Site Plan Review

FINAL ENGINEERING PLANS

BANK OF AMERICA

3035 S ROCHESTER ROAD

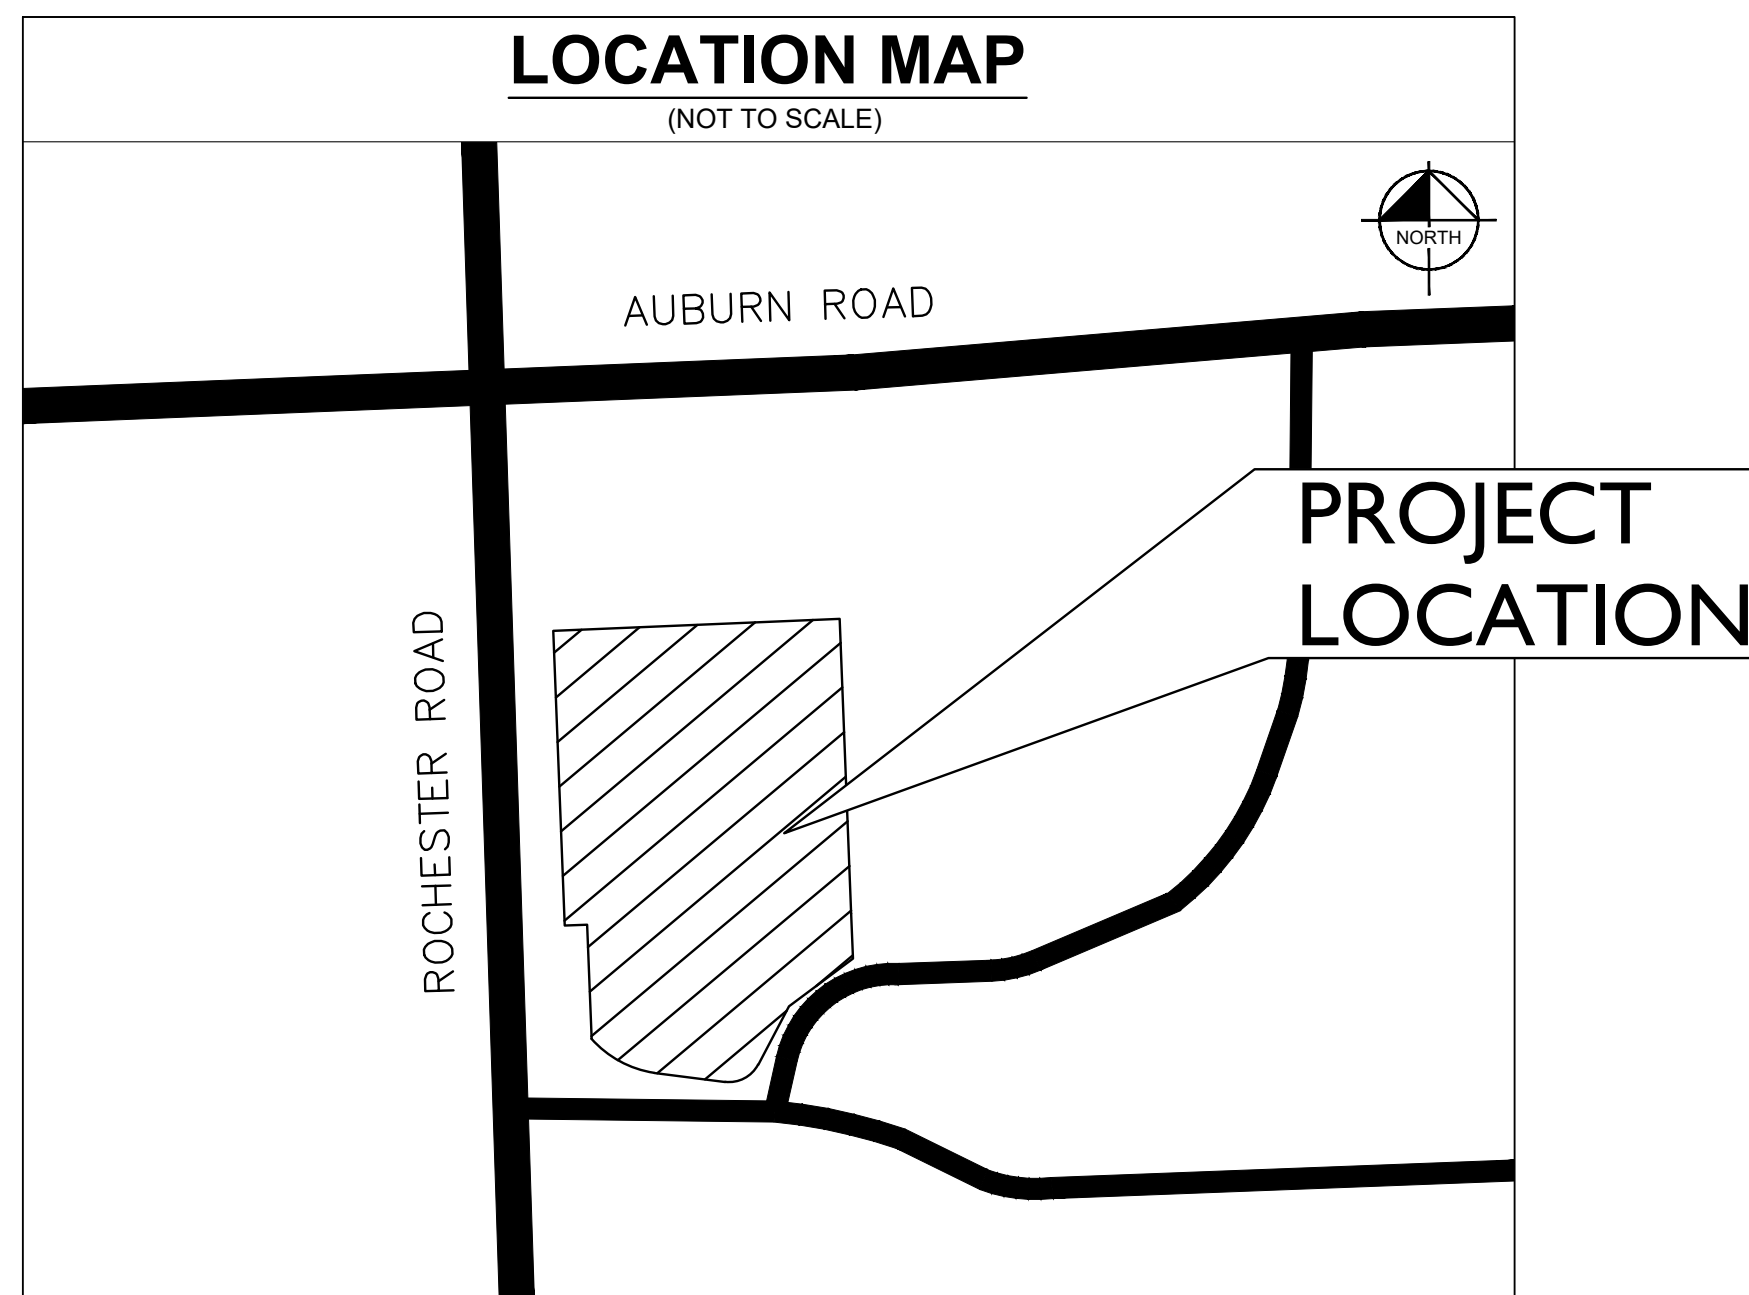
Verify distance

Verify distance

Written legal description and survey description are different. Also, both descriptions do not match the point of commencement on record.

SITE PLAN	BANK OF AMERICA 3035 S ROCHESTER RD ROCHESTER HILLS, MI 48307
SCALE: AS NOTED DESIGNED BY: EC DRAWN BY: EC CHECKED BY: JWG	CITY FILE #22-039 SECTION #35	ORIGINAL ISSUE: 11/18/2022 KHA PROJECT NO. 268266000 SHEET NUMBER	REVISIONS NO. DATE BY 02/06/23 JWG 12/19/22 JWG 12/16/22 JWG	C3.0

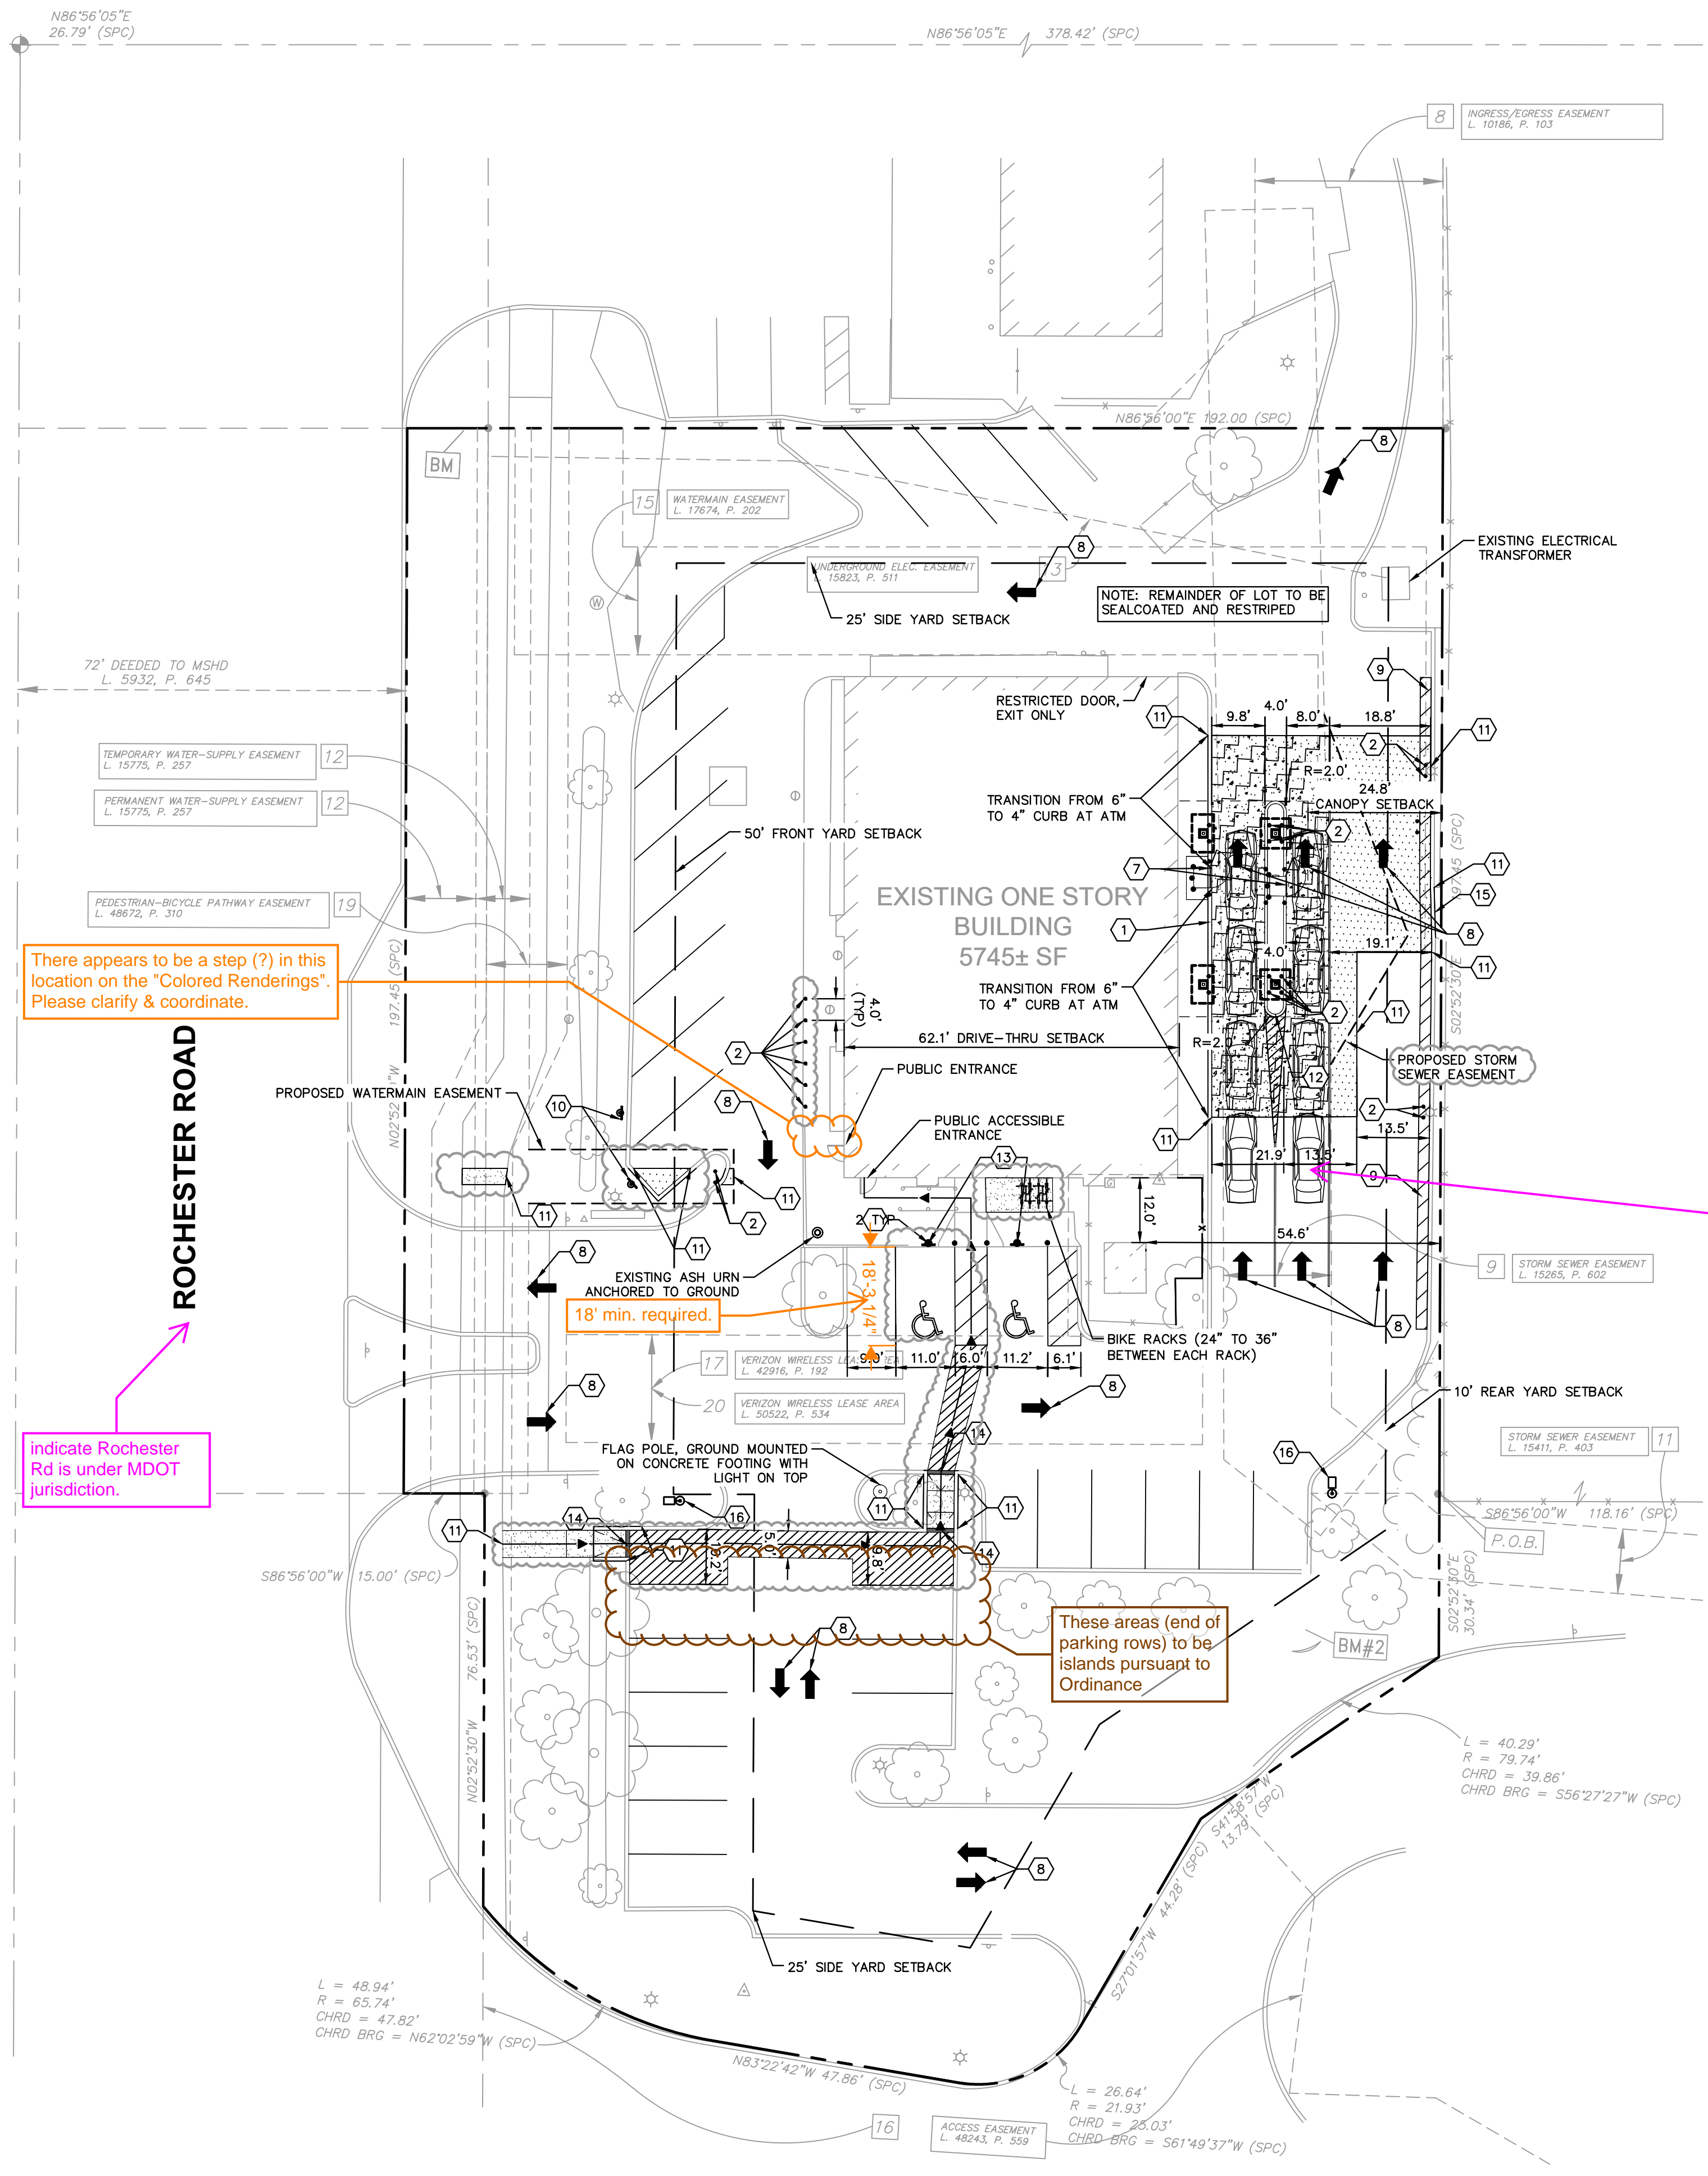
There appears to be a step (?) in this location on the "Colored Renderings". Please clarify & coordinate.

Provide the MDOT for review and copy the City on MDOT's response.

show stacking space size as 16 foot long per City Ordinance or per MDOT's permit requirements, if included with their permit conditions.

BANK OF AMERICA
LANDSCAPE PLAN
3035 S ROCHESTER RD
ROCHESTER HILLS, MI 48307

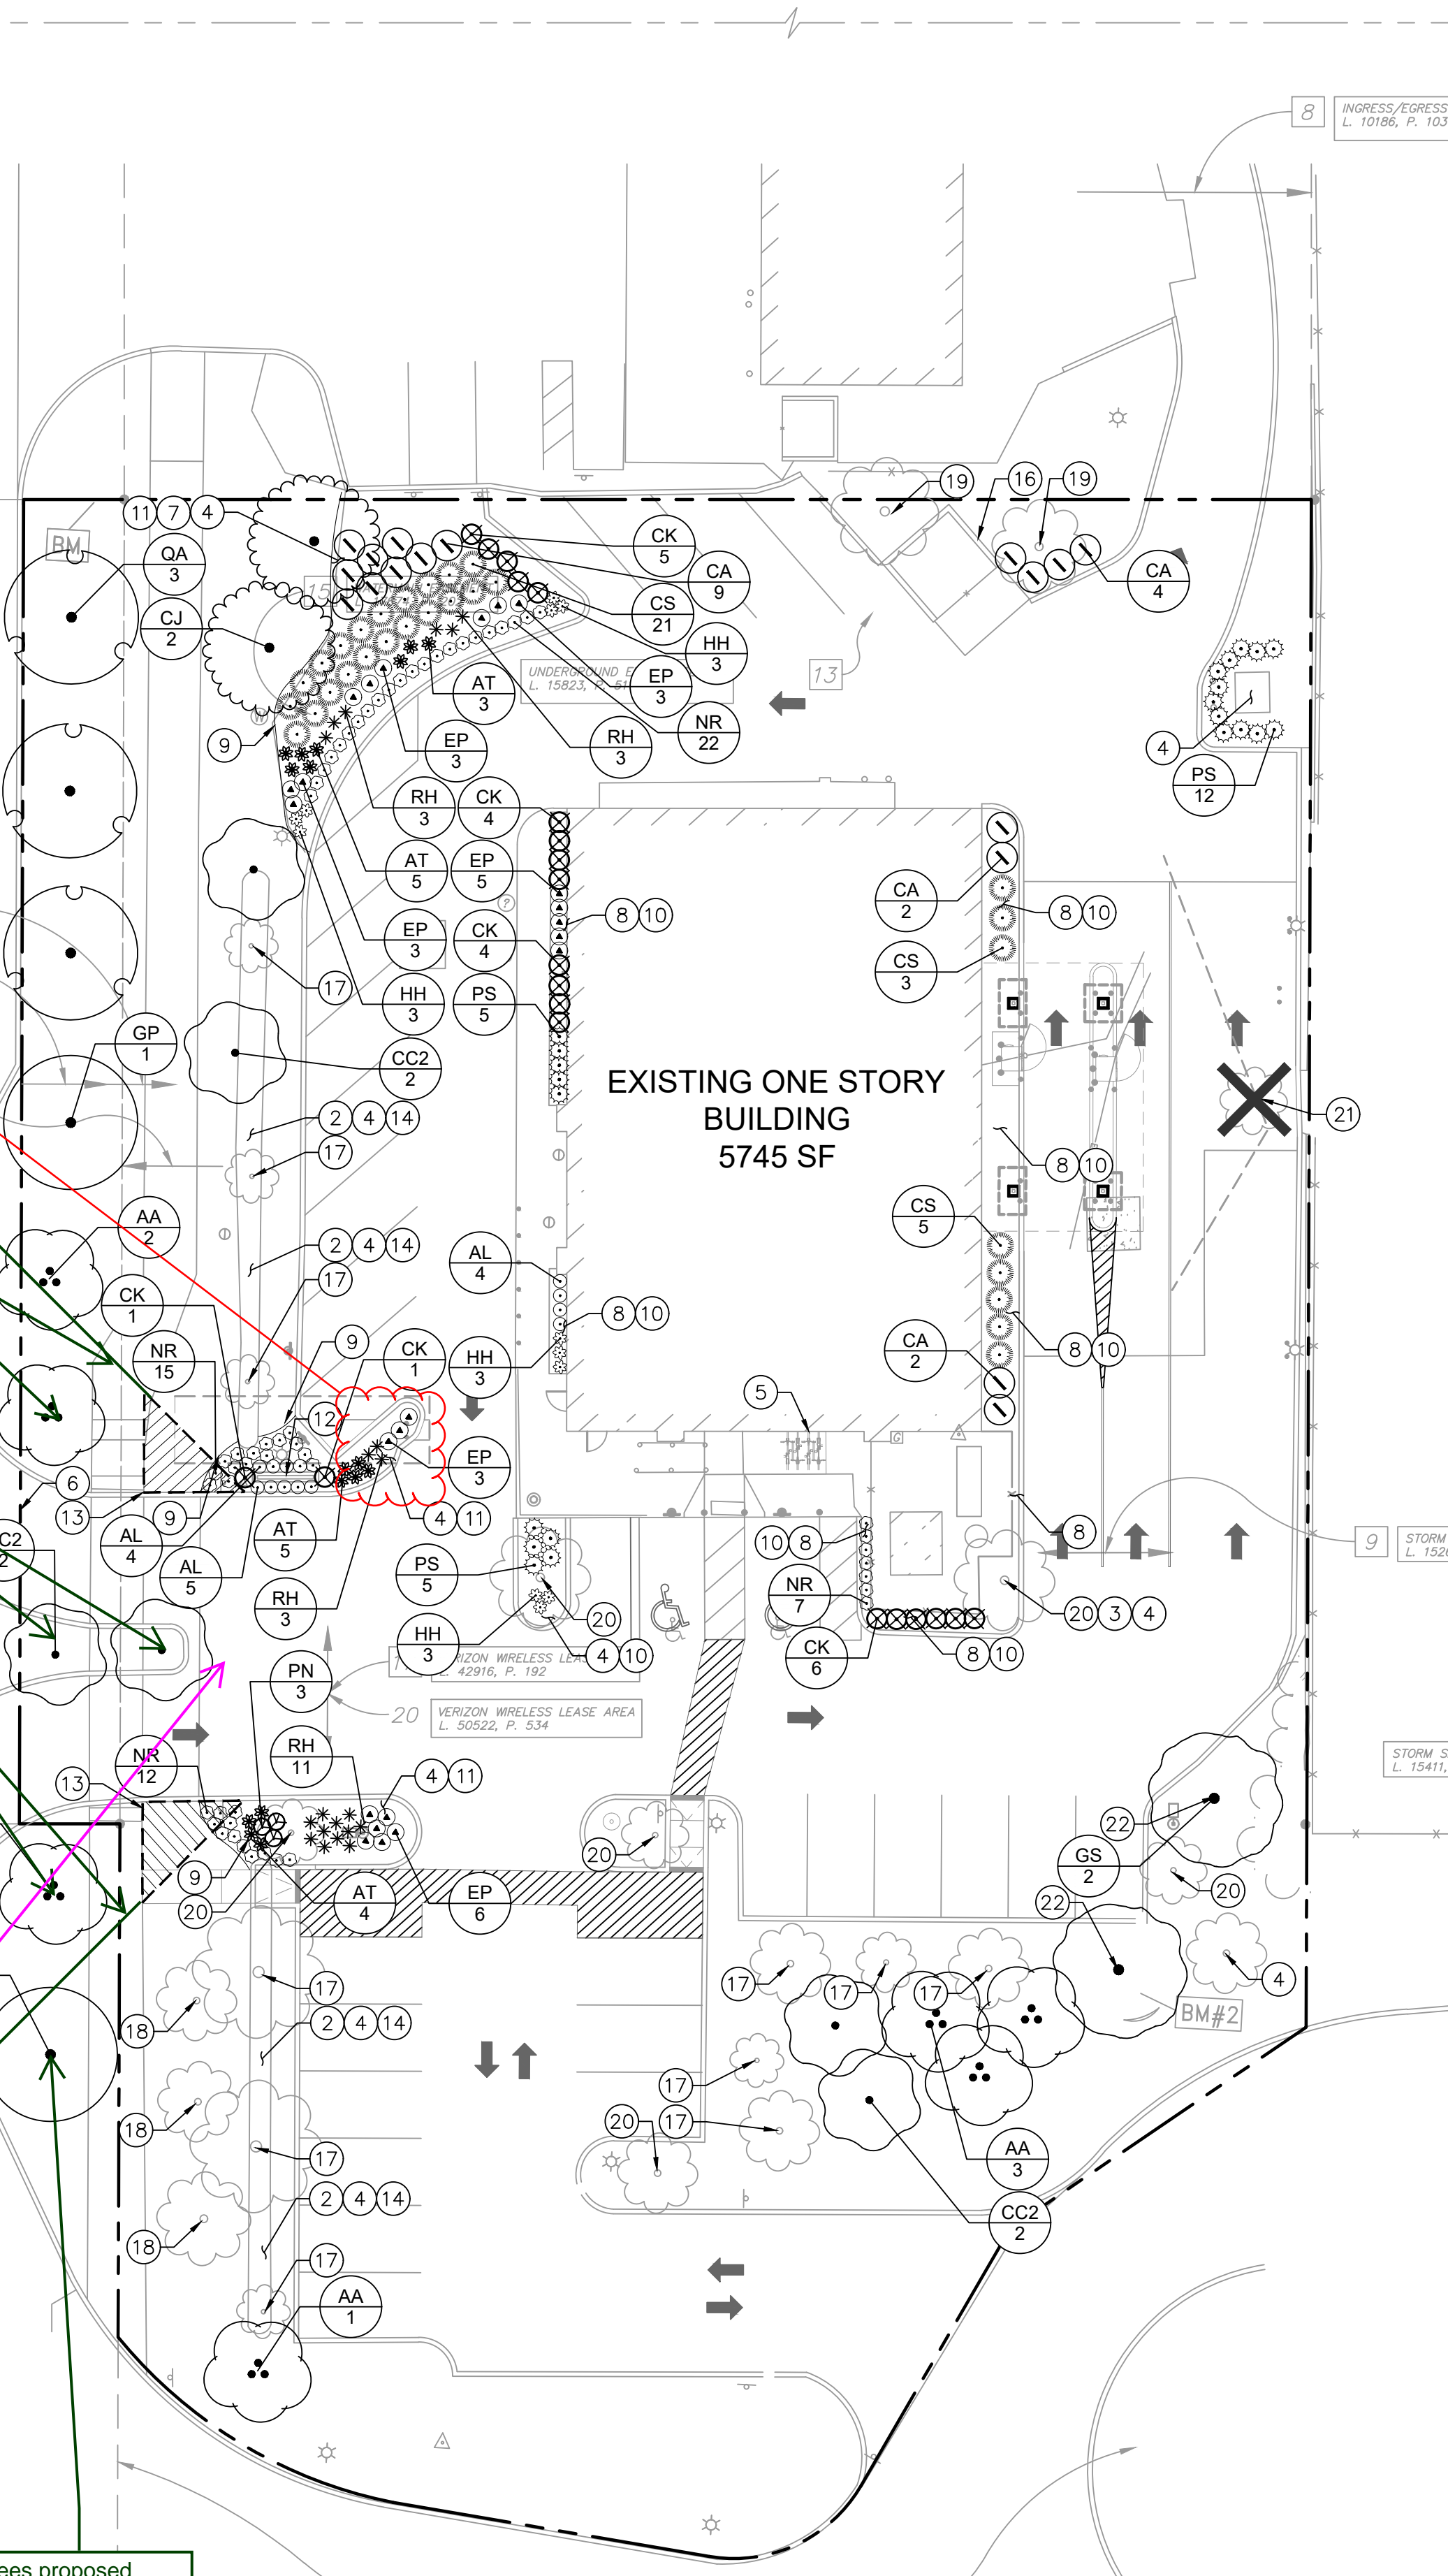
Provide landscape and planting notes/statements including the following:

"Prior approval is required to plant any tree or shrub on the public right-of-way. All trees and shrubs must be planted at least 10' from the edge of the public road. (Trees must be planted at least 15' away from curb or road edge where the speed limit is more than 35 mph.) Shade trees and shrubs must be planted at least 5' from the edge of the public roadway. Evergreen and ornamental trees must be planted at least 10' from the edge of the public walkway. No trees or shrubs may be planted within the triangular area formed at the intersection of any street right-of-way lines at a distance along each line of 25' from their point of intersection. No trees or shrubs may be planted in the triangular area formed at the intersection of any driveway with a public walkway at a distance along each line of 15' from their point of intersection. All trees and shrubs must be planted at least 10' from any fire hydrant. Shade and evergreen trees must be at least 15' away from the nearest overhead wire. Trees must be planted a minimum of 5' from an underground utility, unless the city's Landscape Architect requires a greater distance. Prior to the release of the performance bond, the City of Rochester Hills Forestry Unit needs to inspect all trees, existing or planted, to identify any that pose a hazard to the safe use of the public right-of-way. Forestry may require the developer to remove, and possibly replace, any such trees. The above requirements are incorporated into the plan."

Provide cost estimate of all landscape improvements including irrigation as part of next submittal.

extend Corner Clearance (CC) lines to road edge - remove proposed trees from with CC

This area would also be considered within the corner clearance and should not have any trees planted here. Remove proposed trees.

extend Corner Clearance (CC) lines to road edge - remove proposed trees from with CC

Show Road and Pathway Sight Lines per the attached detail. Trees closest to the curb along Rochester Rd will likely need to be removed once sight lines are shown.

Trees proposed within the Rochester Rd ROW will need a permit to plant from MDOT
